Contract Modification

Contract: 20170509014, Sign Bridge Replacement Regionwide Various Routes

Extend time, Soil Stabilizer, Mobilization (Boring), Removing HMA Long Jt, Nonconforming Conc Pavt

Contract: 20170509014
Cont Mod: 6
Revised Sheet 115

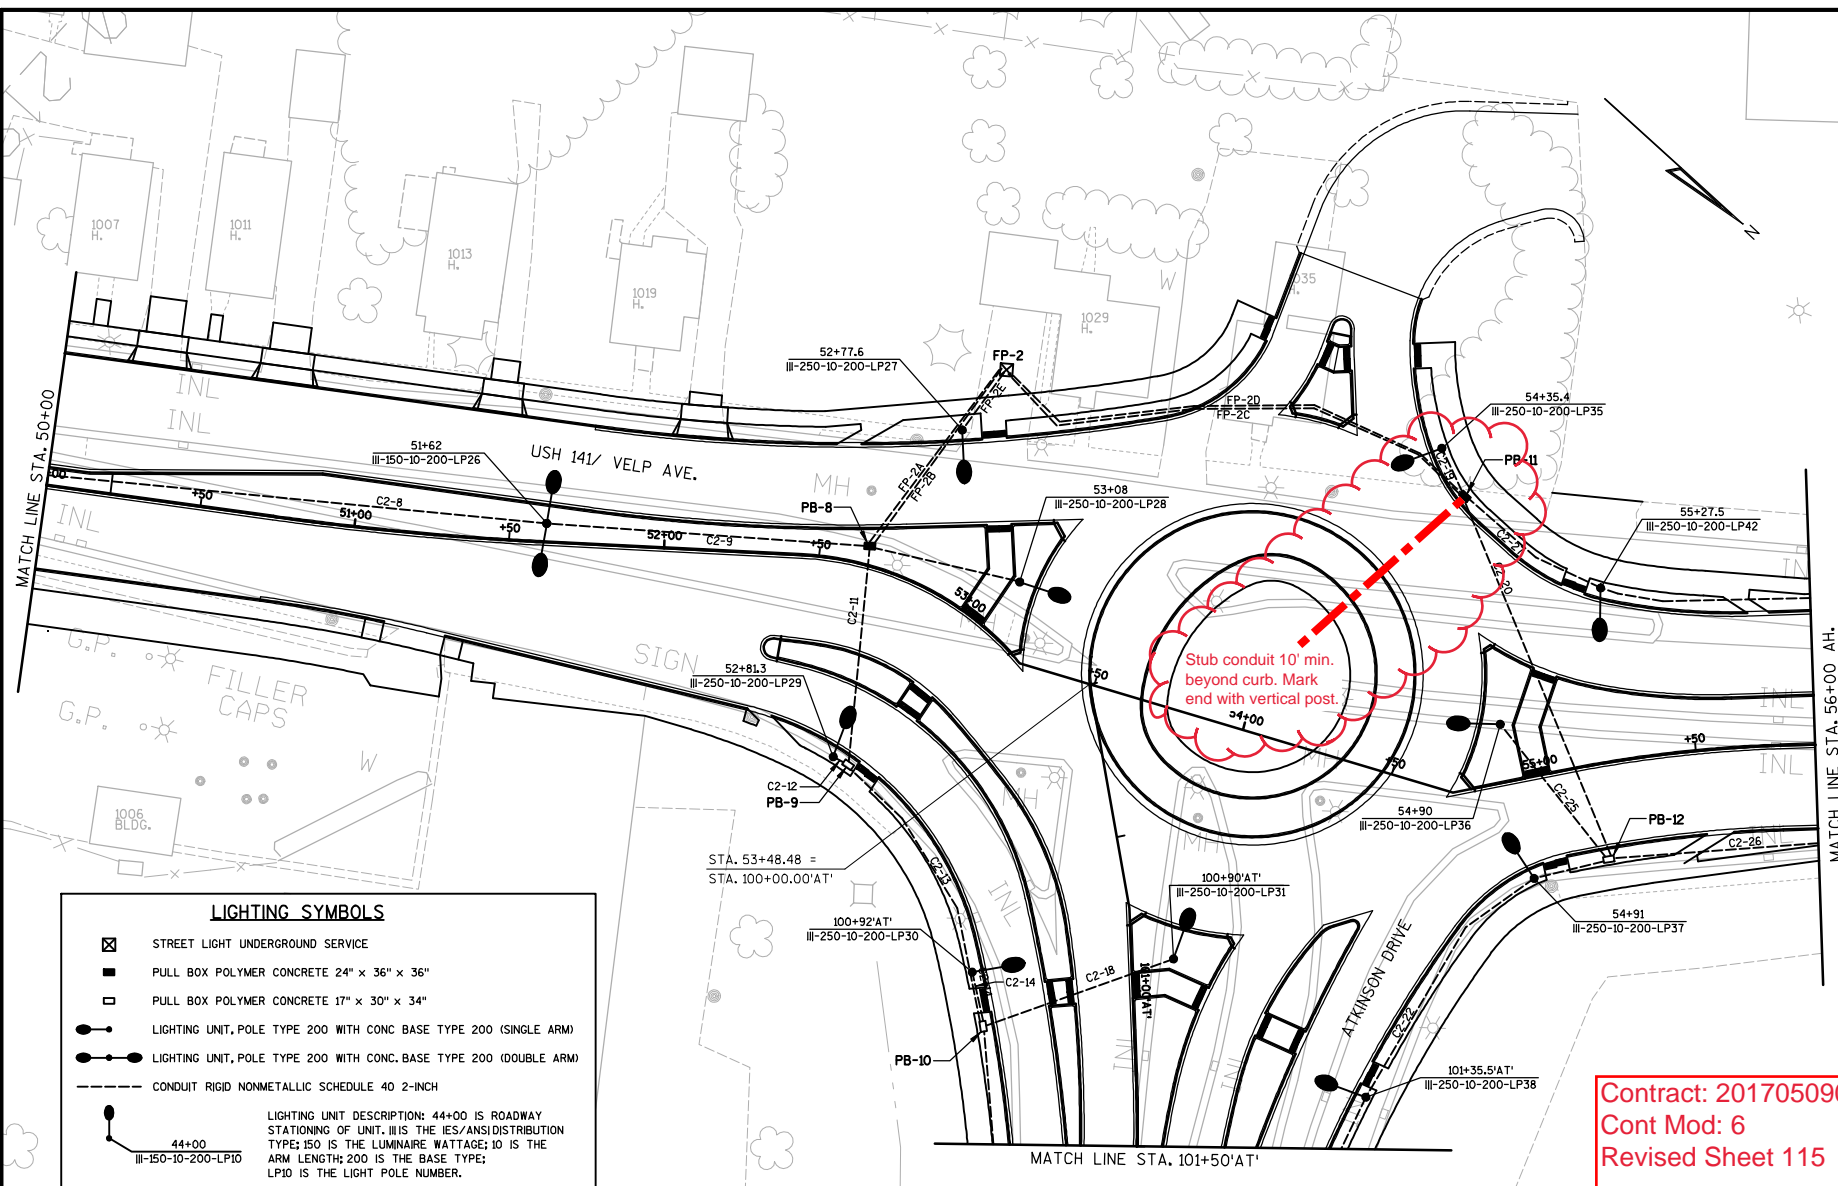
Revised sheet 115 is attached and made part of the plans for this contract.

Reason: RO – The city requested to have an electrical line installed to the center of the roundabout after it was already paved.

Reason: RO – The city requested to have an electrical line installed to the center of the roundabout after it was already paved. This item is being added to mobilize the directional boring machine to the site in accordance with standard spec 104.2.2.1. The 2" conduit will be paid at the contract unit price under item 652.0225 and wiring will be done by others at a later date.
